Site Development Plan_V1.pdf Markup Summary

HIGHWAY 24 & MERIDIAN ROAD SITE DEVELOPMENT PLAN

SITE DEVELOPMENT PLAN
LANDSCAPE
HIGHWAY 24 & MERIDIAN ROAD
FALCON, CO

LS03

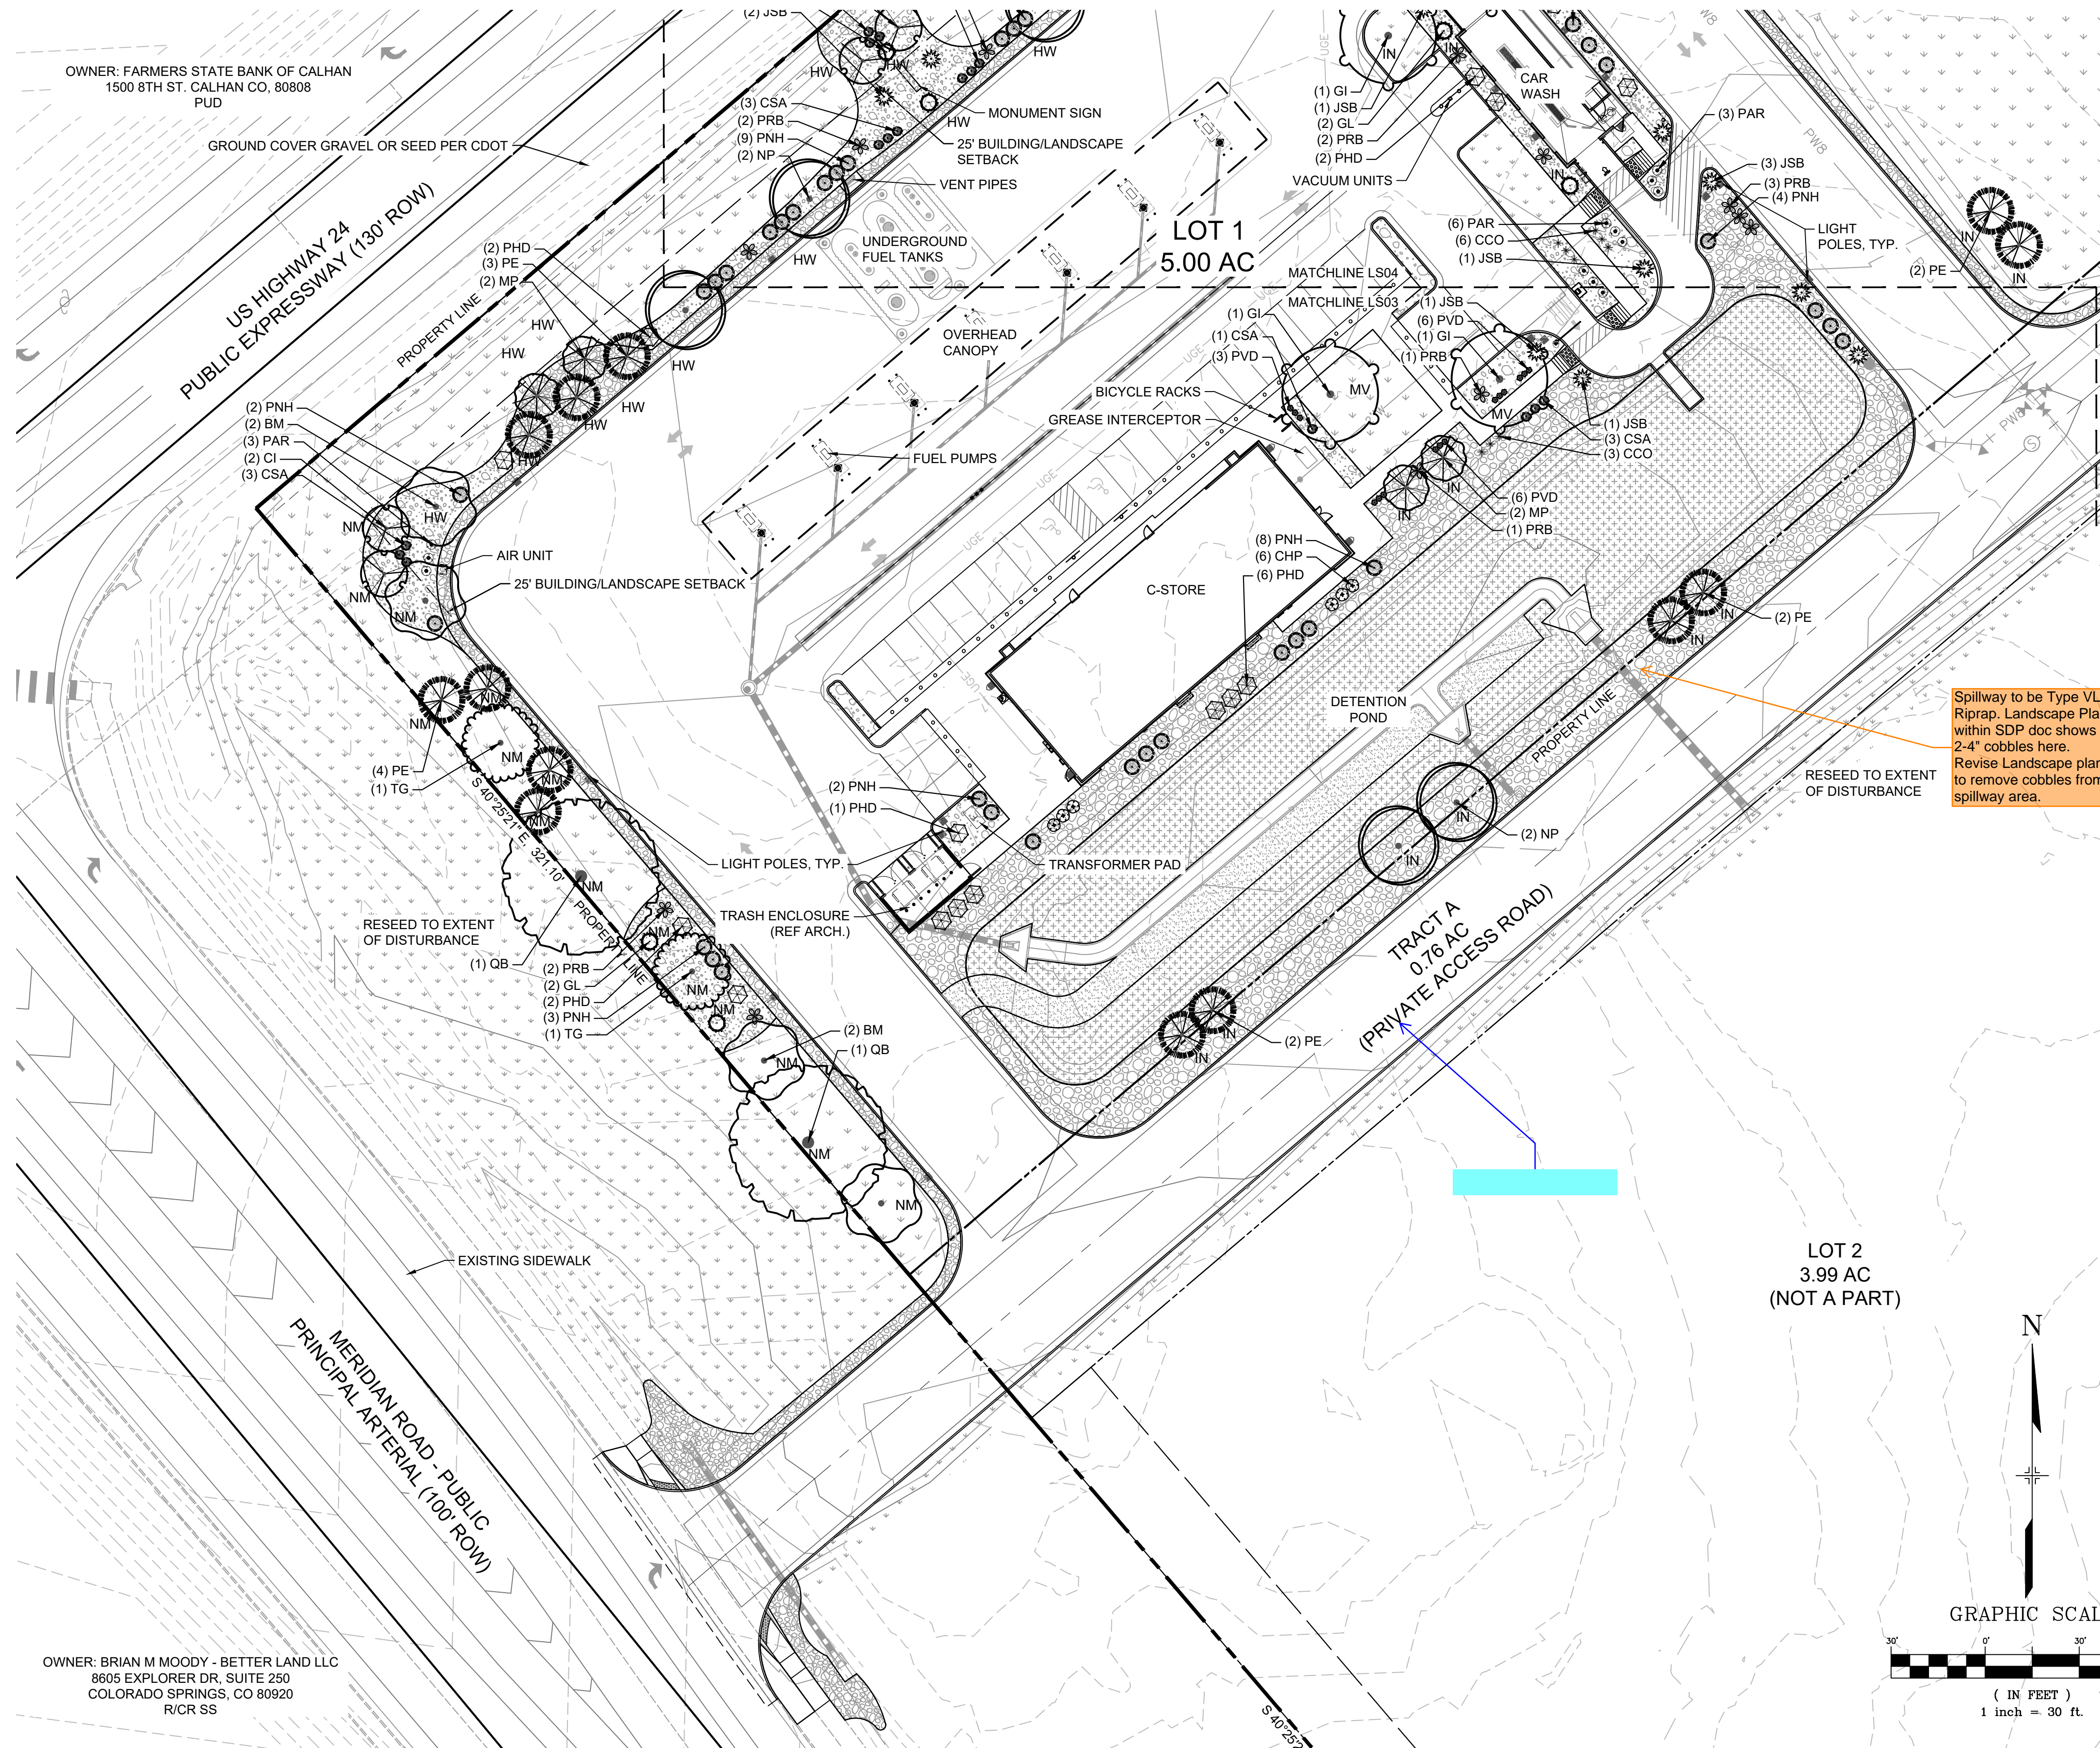
Spillway to be Type VL
Riprap. Landscape Plan
within SDP doc shows
2-4" cobbles here.
Revise Landscape plan
to remove cobbles from
spillway area.
